01-007/14 – 2009-2013 MAZDA6 2.5L (A/T) – UNUSUAL NOISE FROM EXHAUST PIPE SEAL RING

Subject: UNUSUAL NOISE FROM EXHAUST PIPE SEAL RING	Bulletin No: 01-007/14
	Last Issued: 03/17/2014

- This bulletin supersedes the previous bulletins 01-016/12 issued 04/27/12, 06/27/12 and 10/19/12, 01-022/11 issued 06/07/11, 01-044/10 issued 08/06/10, 08/13/10, and 10/15/10, and 01-052/08 issued 11/26/08. The **APPLICABLE MODEL(S)/VINS, PARTS INFORMATION and WARRANTY INFORMATION** have been revised.
- Changes are noted below in Red beside the change bar.

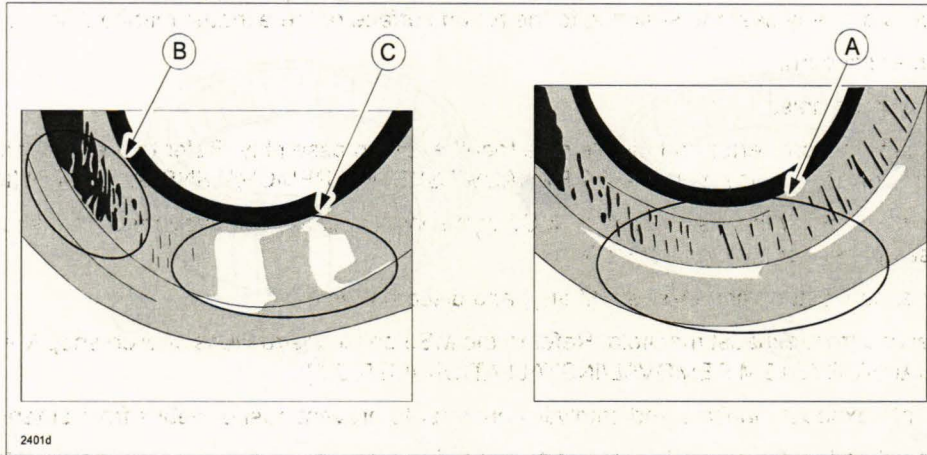
12. If severe damage appears on round surface of catalytic converter-side flared flange (A), replace catalytic converter.

NOTE: If the catalytic converter is replaced and a black coating (B) remains on the round surface of the flared flange, the white coating of the seal ring will stick to the black coating, which may cause noise. Be sure to sufficiently polish the flange (C).

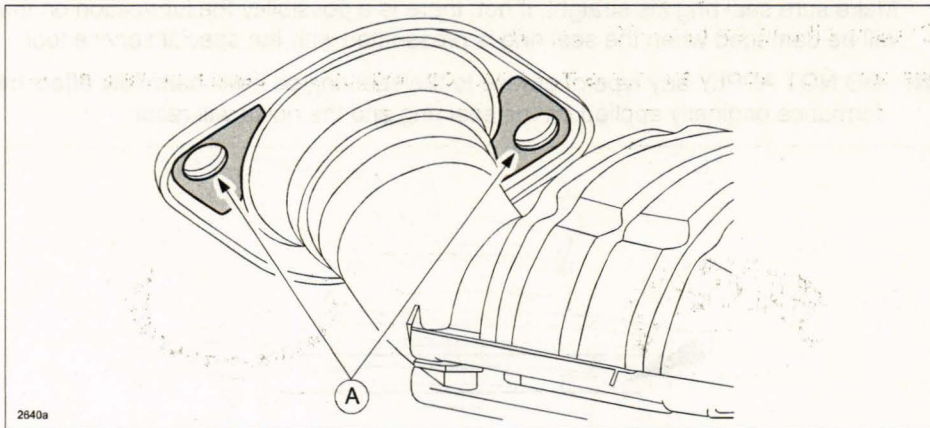
- In case where catalytic converter is NOT replaced:
 - a. Install a new exhaust stud.
 - b. Confirm if patch (A) exists behind the catalytic converter flange.

If YES (patch exists) - Install washer listed in the Part(s) Information to reduce spring tension.
NEVER use an originally equipped washer.

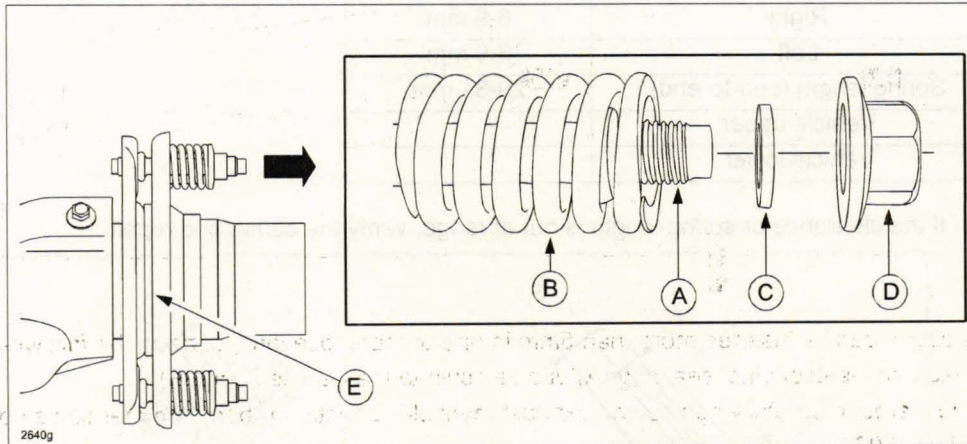
21. Install springs, washers (when necessary according to Step 11), and hex nuts in order.

- A - Exhaust Stud
- B - Spring
- C - Washer - (washer fits inside spring against stud shoulder)
- D - Hex Nut
- E - Seal Ring

NOTE: It is NOT necessary to install washers when the catalytic converter is replaced with a new one.

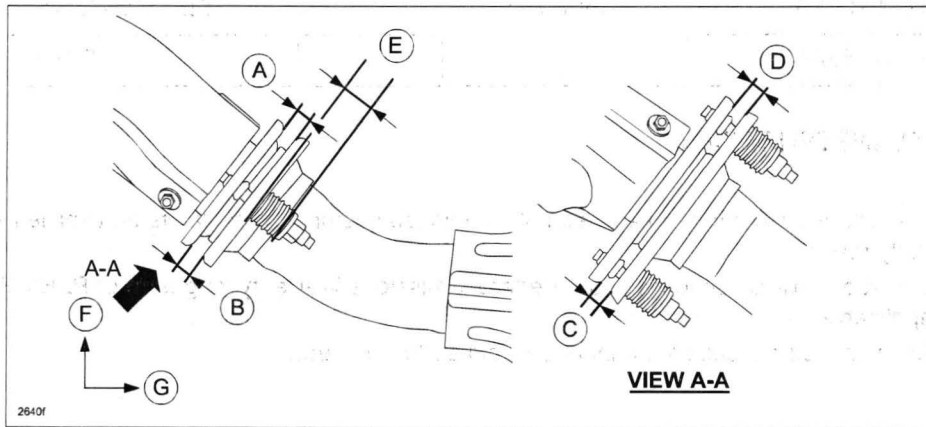
23. Measure the length and clearance between the flanges of the exhaust manifold and U/F catalytic converter. Verify that they are within the specification shown.

A	Upper	9-12 mm
B	Lower	7-10 mm
C	Right	6-9 mm
D	Left	6-9 mm
E	Spring length (end-to-end)	29-31 mm
F	Vehicle upper	
G	Vehicle lower

NOTE: If the clearance or spring length is out of range, verify the cause and repair.
